Discretionary Review Abbreviated Analysis HEARING DATE: MAY 14, 2020

Date: May 7, 2020
Case No.: **2018-005918DRP-02**
Project Address: **254 Roosevelt Way**
Permit Application: 2019.0212.2711
Zoning: RH-2 [Residential House, Two-Family]
40-X Height and Bulk District
Block/Lot: 2607 / 029
Project Sponsor: Linda Kahn
720 York Street #107
San Francisco, CA 94123
Staff Contact: David Winslow – (415) 575-9159
david.winslow@sfgov.org
Recommendation: **Take DR and Approve with Modifications**

Discretionary Review Hearing
 Case Number 2018-005918DRP-02
 254 Roosevelt Way

311 Notification Plans, Location of Unit 3/Level 3 Rear Exit at Matching Light Well

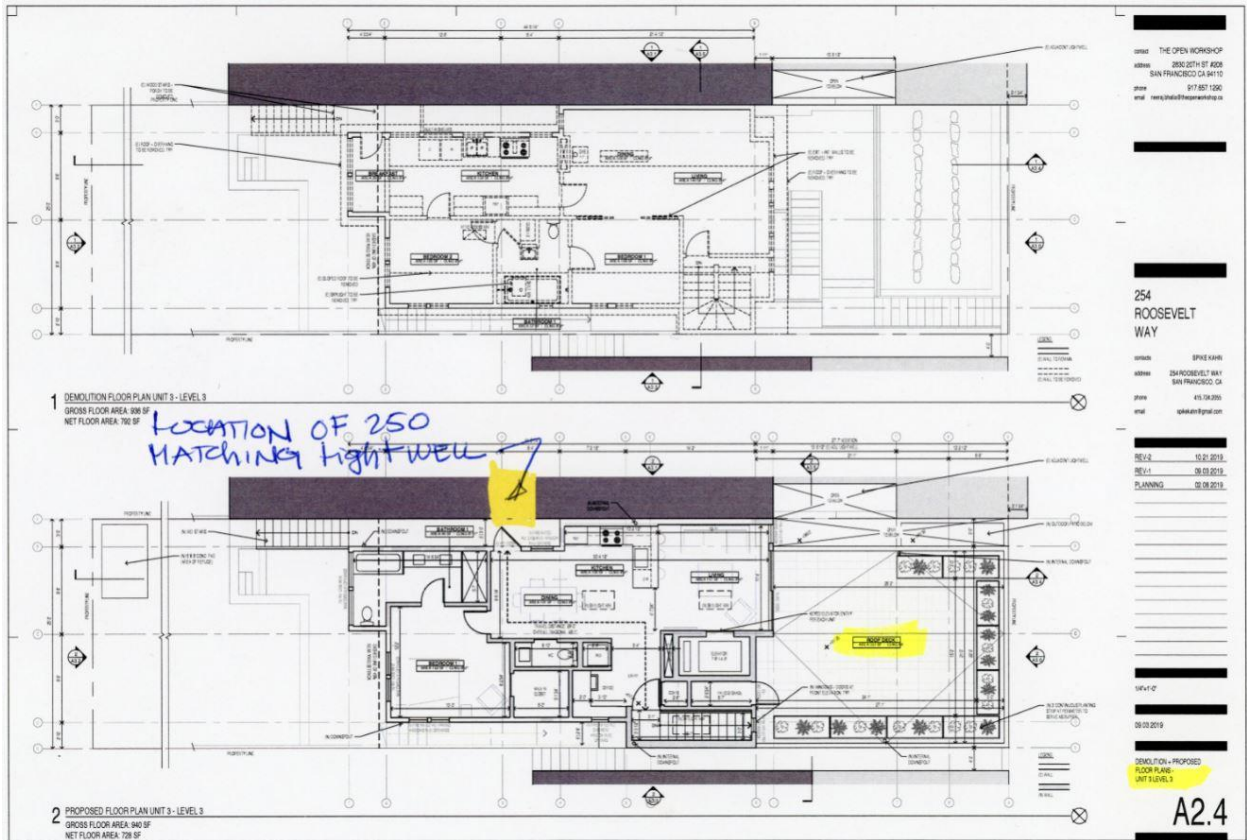
2. **Unit 3/Level 3 Rear Exit at Matching Light Well** - Light and air impact in the existing rear light well of two homes at 250 Roosevelt, apartments #2 and #3, due to the proposed construction of an exterior access door and catwalk structure in the matching light well of the project. Please note the Developer does not show the matching light well of 250 in her Project drawings despite multiple requests to do so. (See 311-Notification Sheet A2.4 and Exhibit-2 Unit 3/Level 3 Rear Exit at Matching Light Well)

Fig. 2A

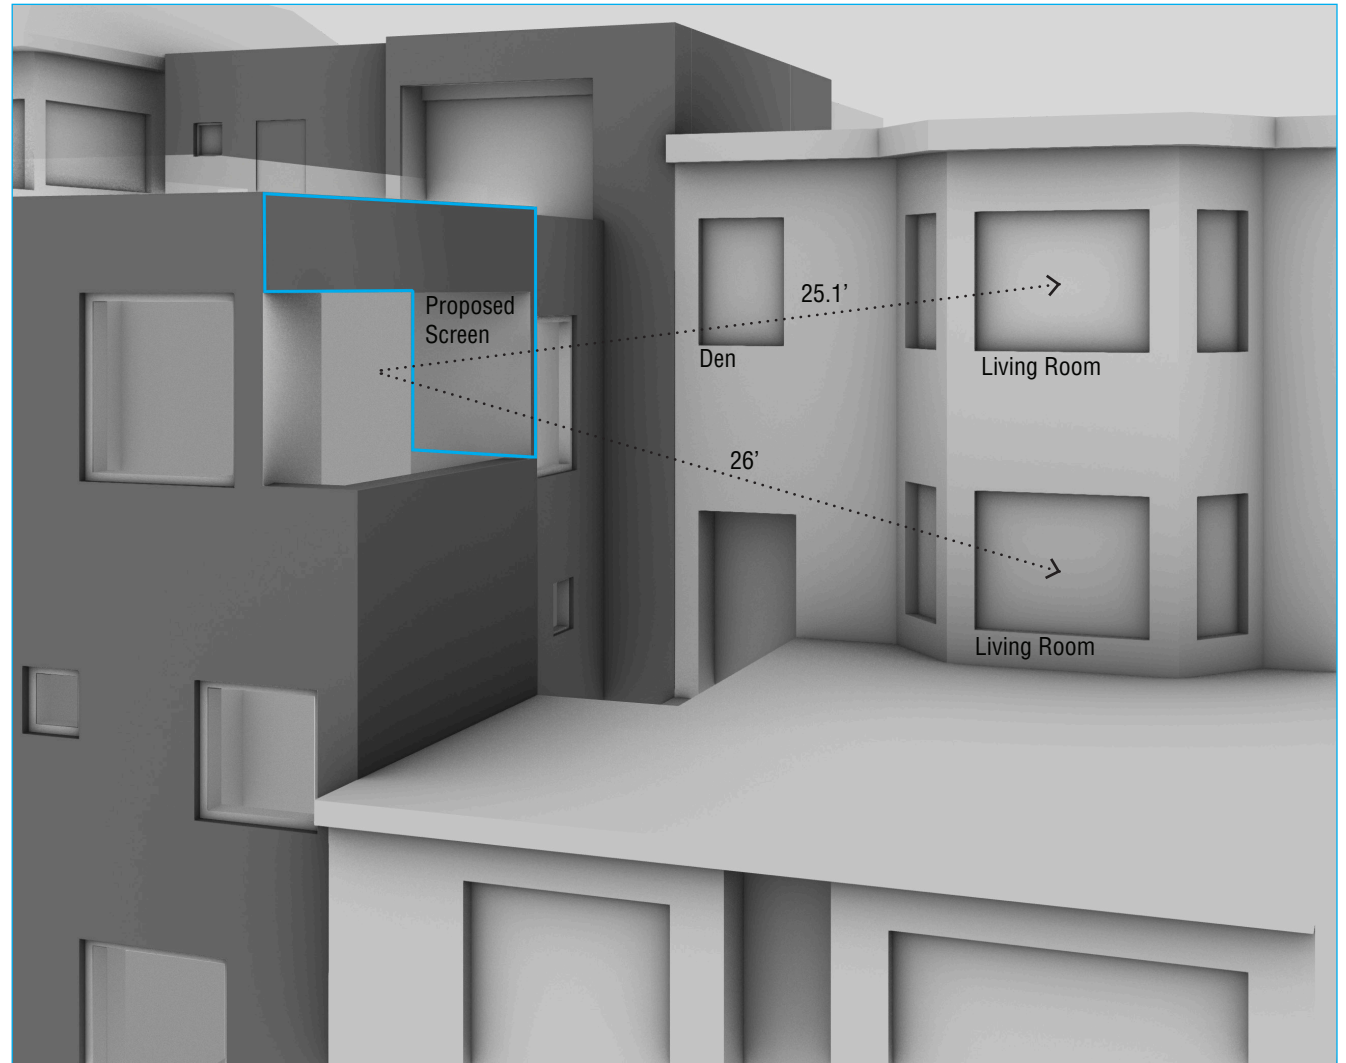
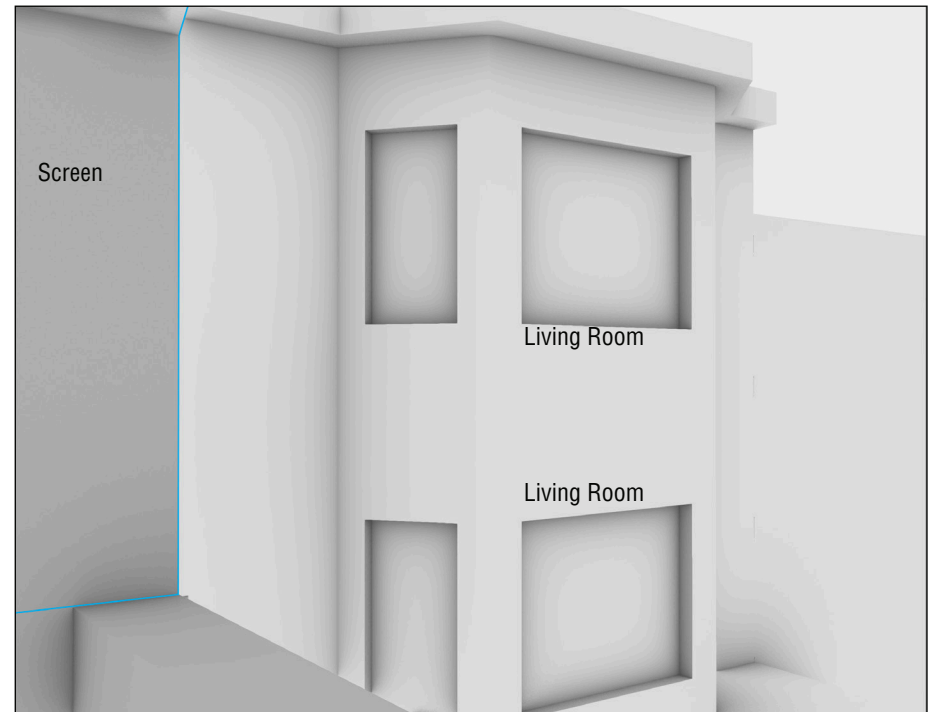
Provide Architectural/ Vision Screen at the north railing. As currently designed, this patio area provides direct vision into 3 units of 250: (i) **the living room of 250-2**, (ii) **the living room and bedroom of 250-3**, and (iii) the bedroom of 250-1. Requiring construction of a vision screen at the northern end of the deck would prevent direct visibility into the living spaces of 3 units in 250.

As recommended by the DR requester, we offered a screen at the north edge of the balcony to provide screening. We found this effective at creating privacy to the Den at 250-3. The view into the living rooms is over 25 feet away. While we feel the screen is unnecessary due to the distance from the house, we offered this option (DR requester rejected the proposal despite it being their idea). (See Fig. 2B/ 2C)

Fig. 3A
Partial Level 2 Plan
Originally submitted for 311

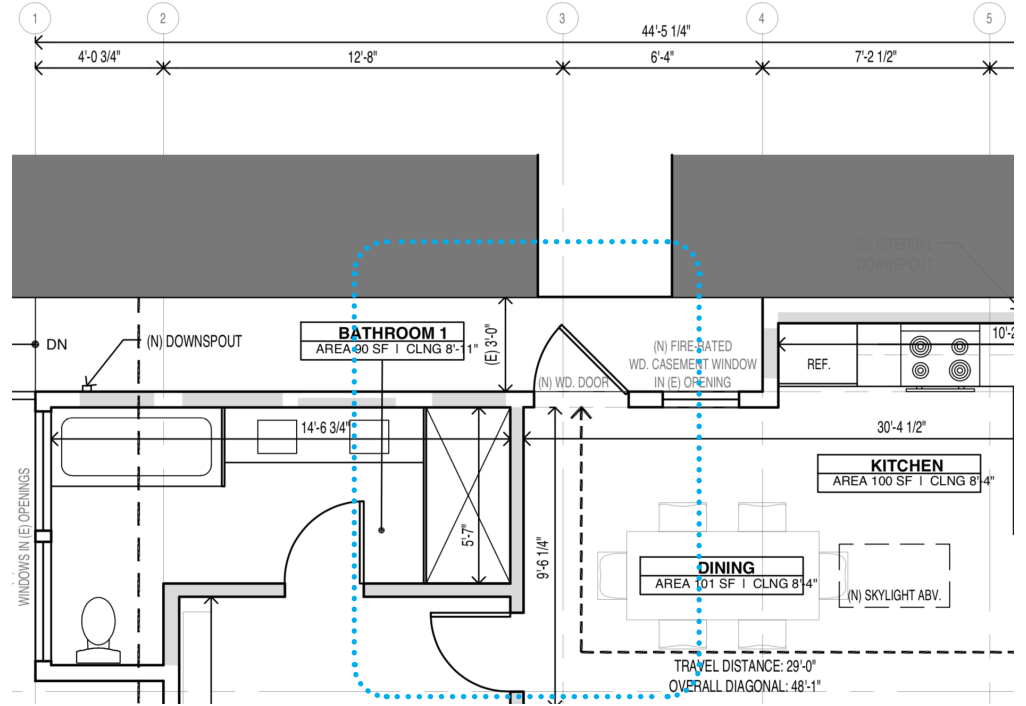
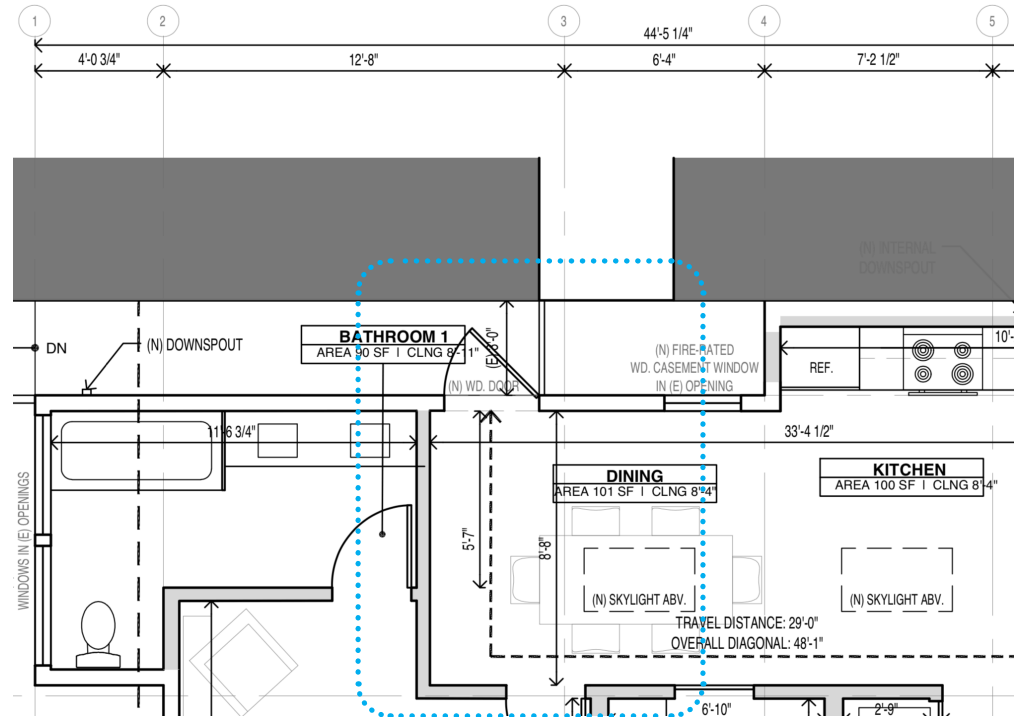
The requester's description of privacy issues for bedroom in 250-1 is inaccurate in the DR. There are two solid doors and one recessed window below a set-back (see Fig 2E). From the angle of view from the proposed patio, there is no loss of privacy to the lower level windows on 250 Roosevelt (Fig 2D).

Fig. 3B
Partial Level 2 Plan
Revised Exit to maintain privacy

Fig. 4A
Roof Deck
Originally submitted for
311

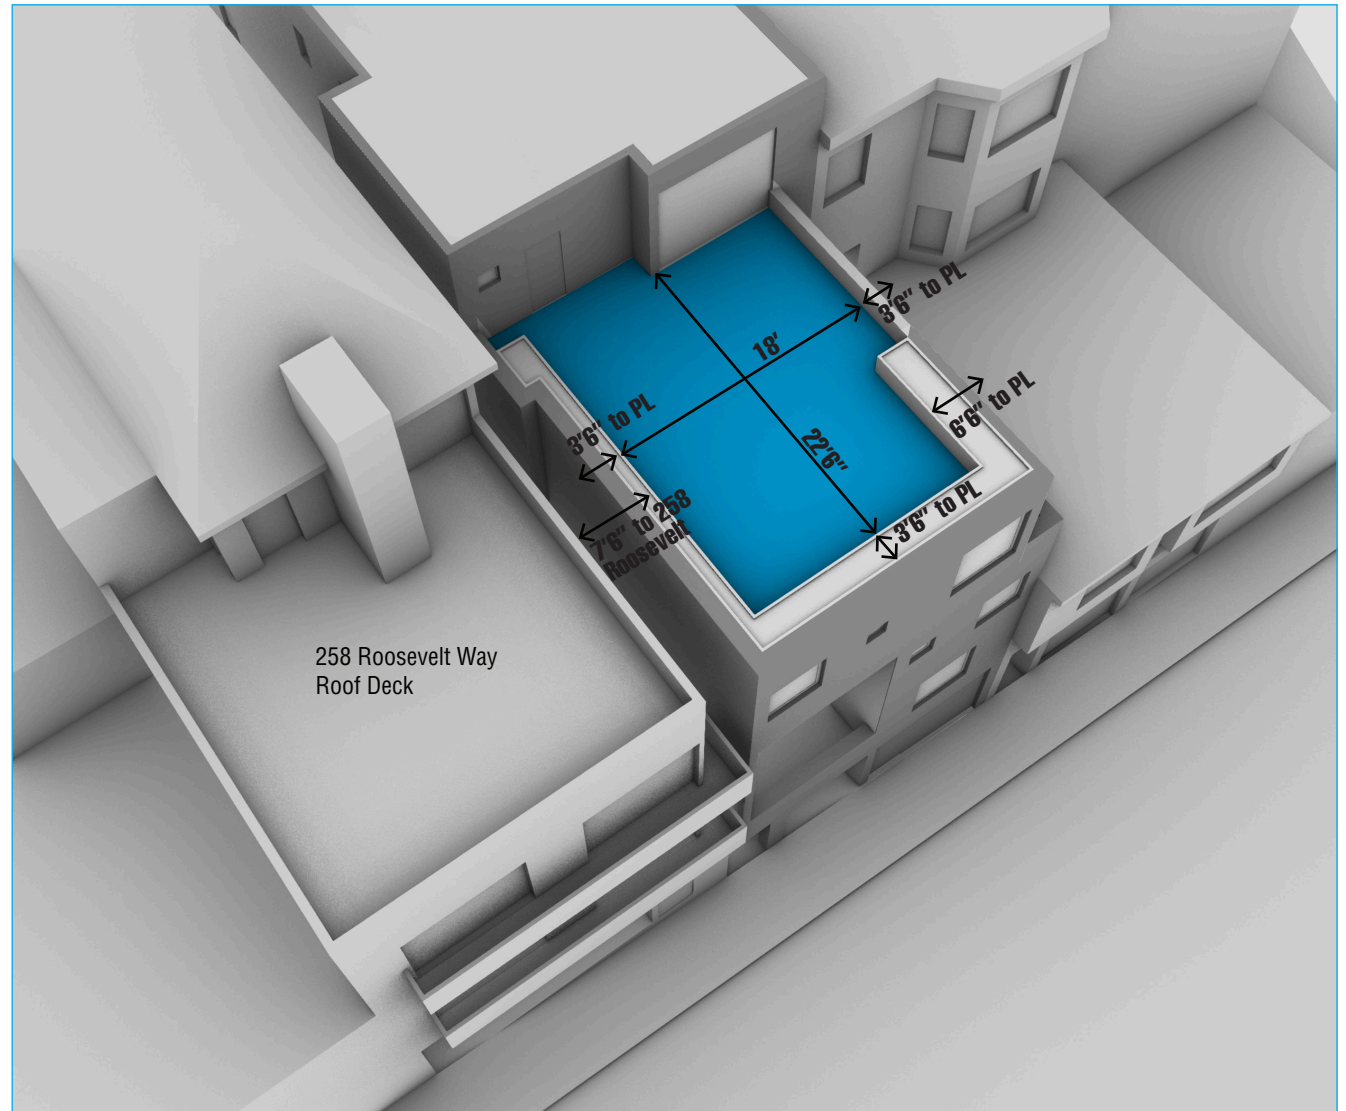
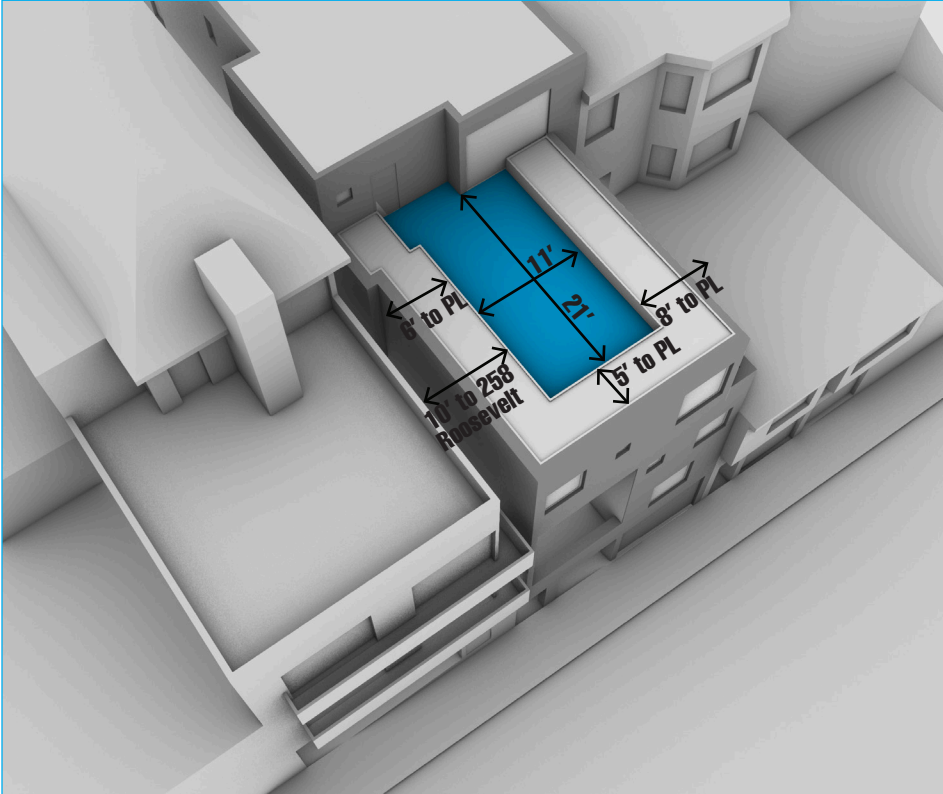
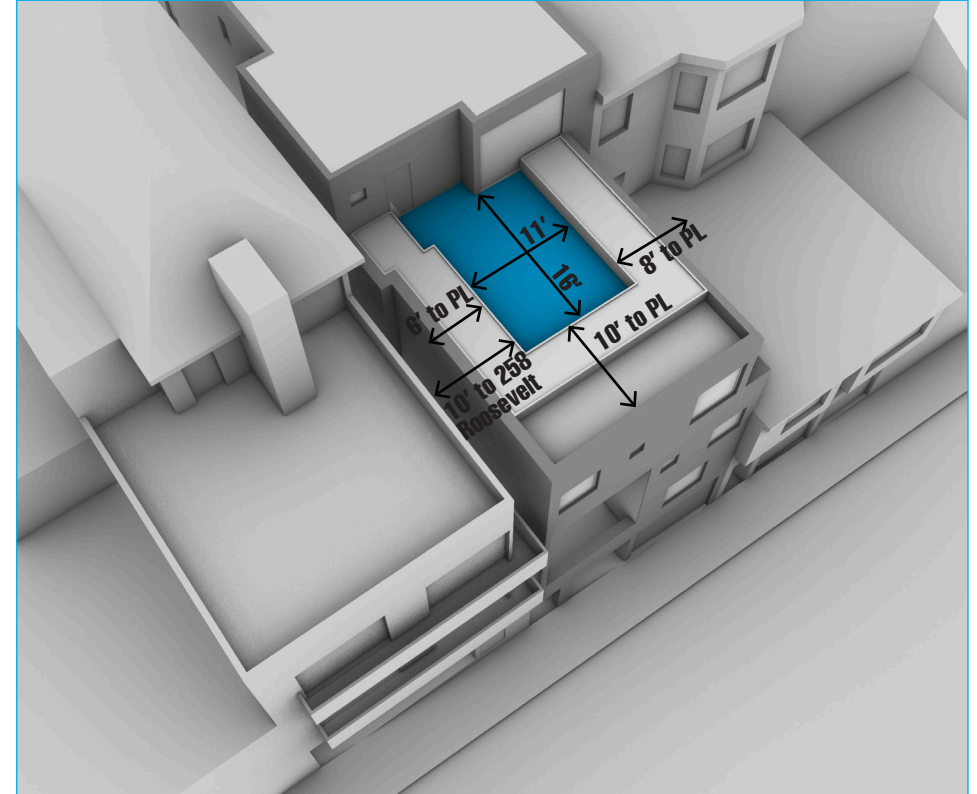
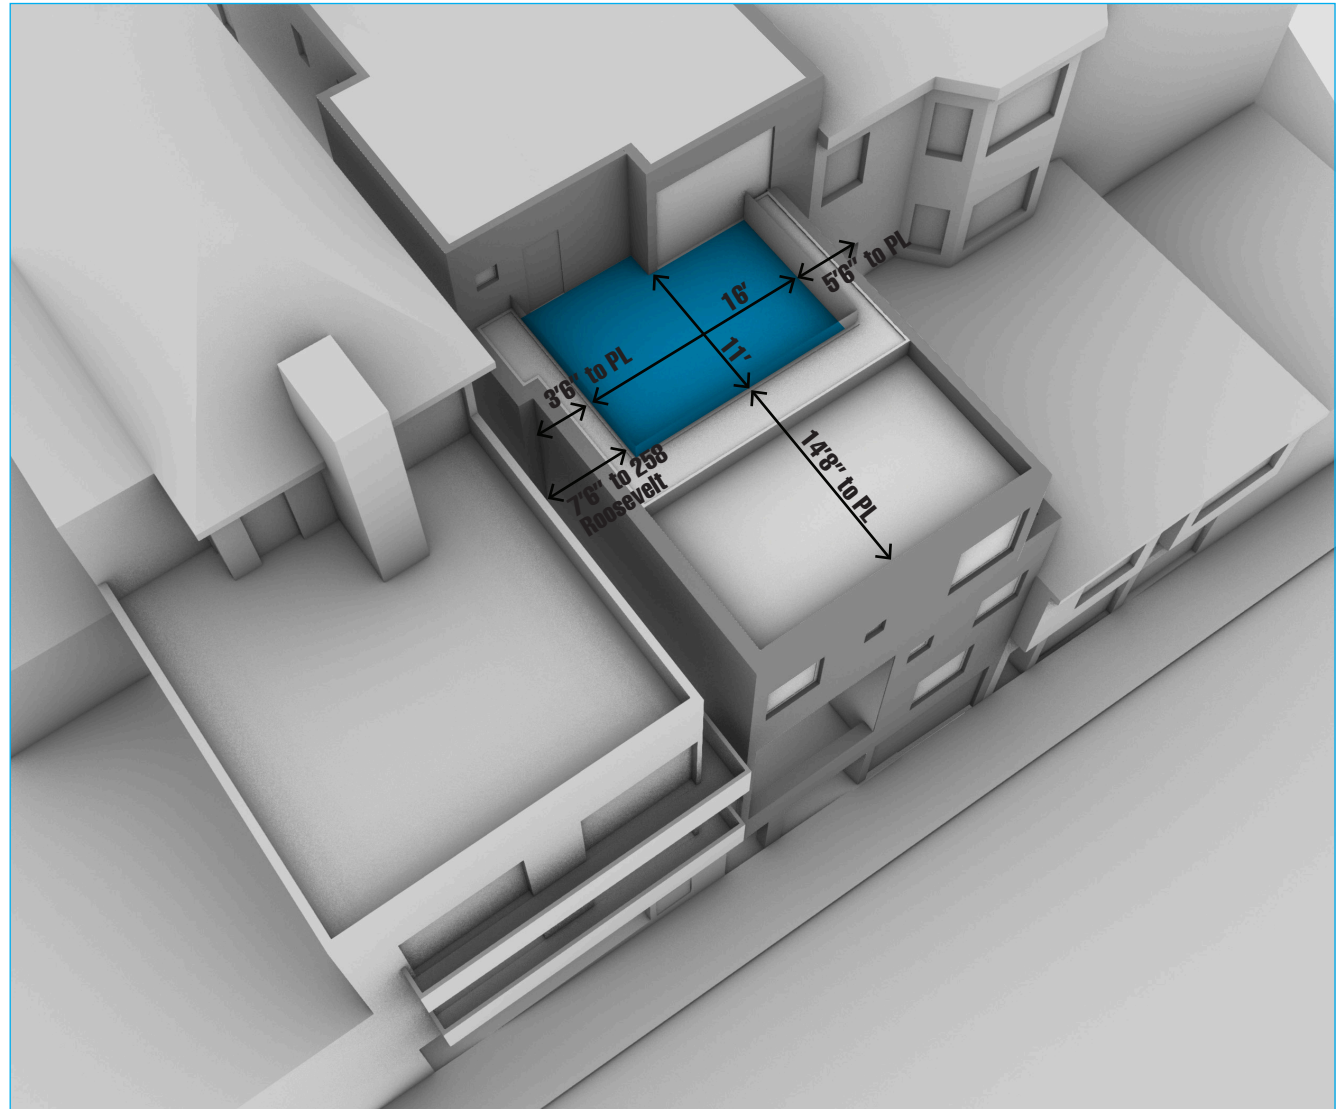
The proposed roof deck is in keeping with the adjacent roof deck at 258 Roosevelt Way (See Fig 4A). The proposed roof deck contains a 3 foot planted perimeter for privacy (which 258 does not provide). The roof deck will be property of the top unit, while the rear yard will belong to the middle unit.

Since the DR was filed, the project sponsor has done a series of studies to negotiate with the neighbors. The first negotiation of a 5' planter is presented on the left.

In further conversation with Principal Architect — Design Review, David Winslow, the roof deck was adjusted by rotating its geometry to reduce the view angle back to the adjacent properties. This final proposal leaves 14'-8" setback from the front of the property, 5'-6" setback to the property line of 250 Roosevelt Way, and 3'-6" to the property line of 258 Roosevelt Way (7'-6" set back from the building face). The reason for this rotation, was to reduce the visibility of the roof deck from the two adjacent properties (See Fig. 4E and 4F).
